ATTACHMENT B: REVISED TECHNICAL SPECIFICATION PAGES

3.4 STANDBY LIQUID CONTROL SYSTEM

ATTACHMENT C: MARKED-UP PAGES

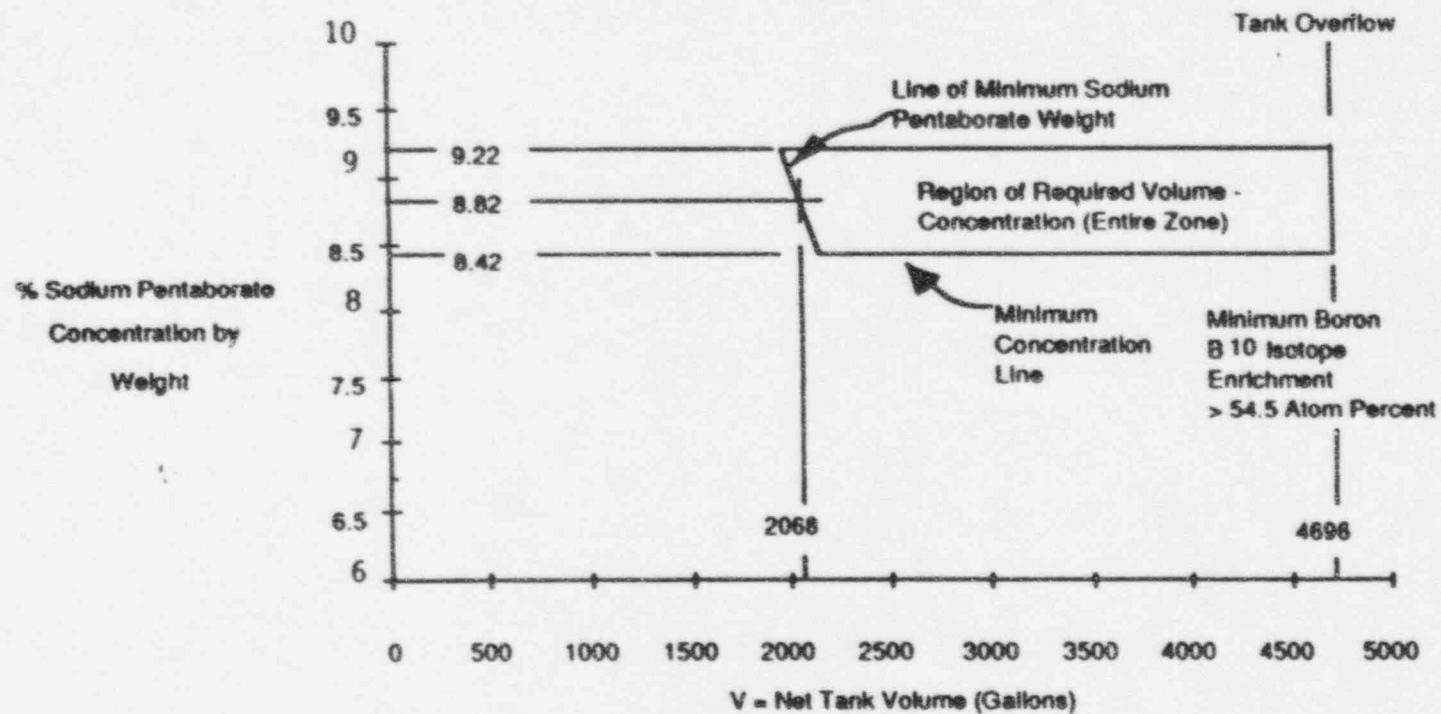
- A. With concentration of boron in solution not within limits but $> 8\%$, restore concentration of boron in solution to within limits within 72 hours AND 10 days from discovery of failure to meet the LCO.
- B. With one SLC subsystem inoperable for reasons other than Condition A, restore SLC subsystem to OPERABLE status within 7 days AND 10 days from discovery of failure to meet the LCO.
- C. With two SLC subsystems inoperable for reasons other than Condition A, restore one SLC subsystem to OPERABLE status within 8 hours.
- D. Required Action and associated Completion Time not met, be in Hot Shutdown within 12 hours.

3.4 STANDBY LIQUID CONTROL SYSTEM (Cont)

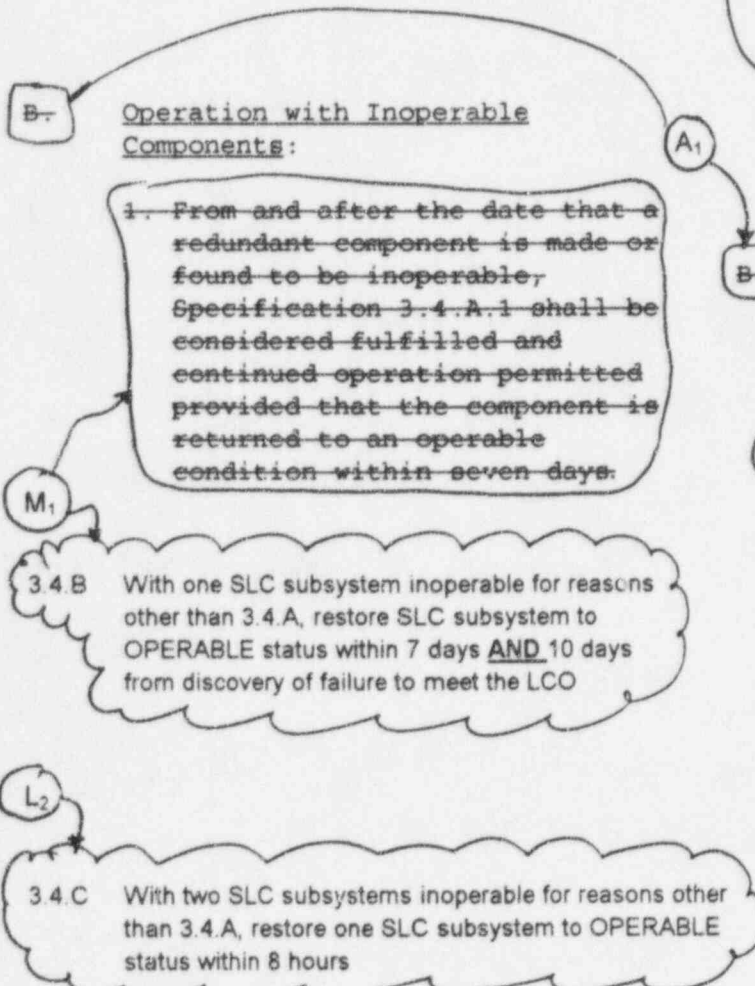
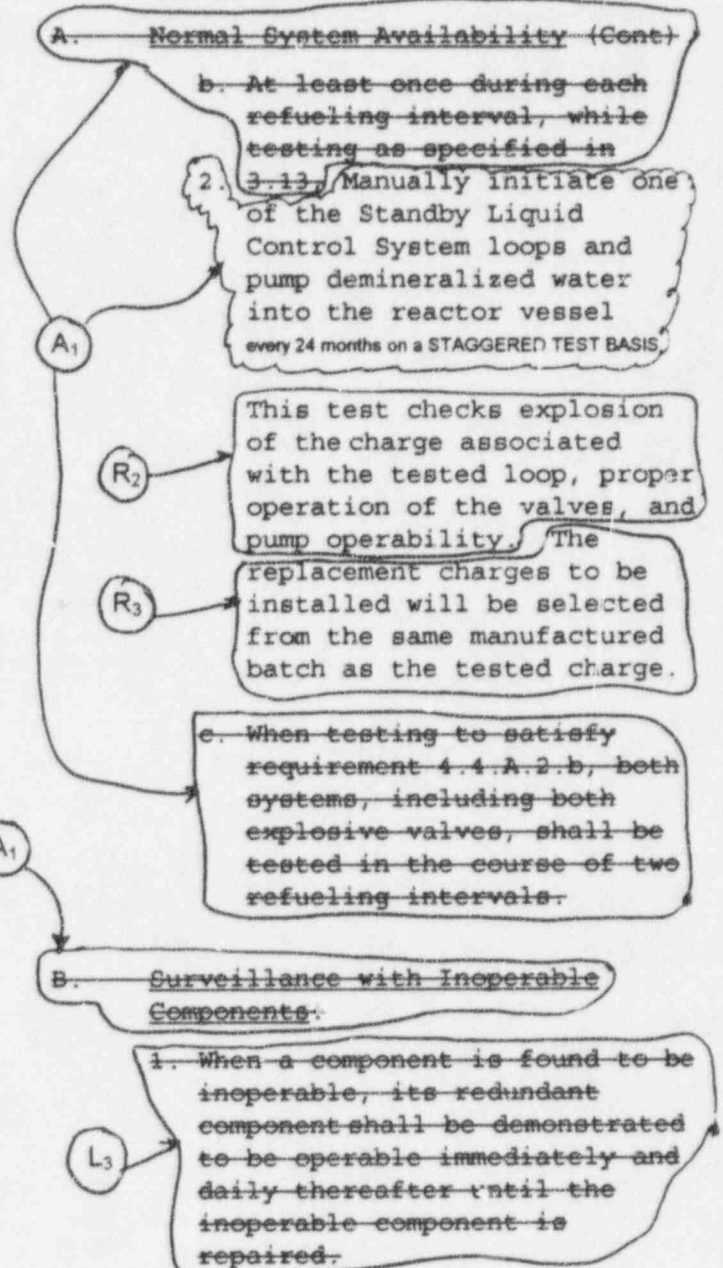
- A₁ 1. During periods when fuel is in the reactor and prior to startup from a Cold Condition, the Standby Liquid Control System shall be OPERABLE, except as specified in 3.4.B below. This system need not be operable when the reactor is in the Cold Shutdown Condition, all operable control rods are fully inserted and Specification 3.3.A is met.
- Two SLC subsystems

L₁ APPLICABILITY: Run and Startup MODES

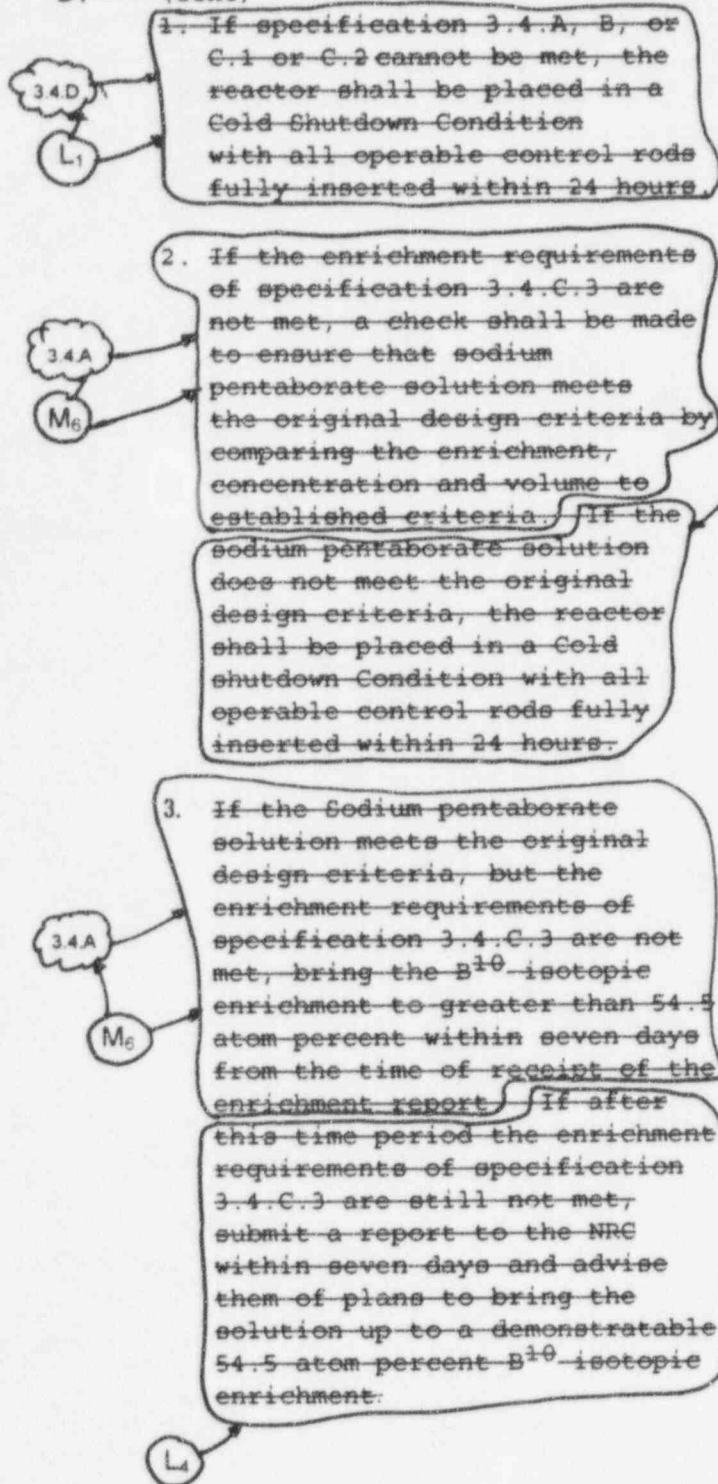
6. 3. Concentration: Check at least once per month. Also check of boron in solution is ≤ 9.22 % weight and limits of Figure 3.4-1. Concentration anytime water or boron is added to the solution or the solution is at or below 48°F. every 31 days.

AND once within 24 hours after

4. Enrichment: Check B¹⁰ enrichment level by test anytime boron is added to the solution and during each refueling outage. Enrichment analyses shall be received within 30 days of test performance. If not received within 30 days, see Table 6.9.1 for reporting requirements.

7. Verify sodium pentaborate enrichment is ≥ 54.5 atom percent B-10 prior to addition to SLC tank.

3. Verify continuity of explosive charge every 31 days

8. Verify all heat traced piping between storage tank and pump suction is unblocked every 24 months
AND
Once within 24 hours after solution temperature is restored to > 48°F.

9. Verify temperature of pump suction piping is > 48°F every 24 hours.
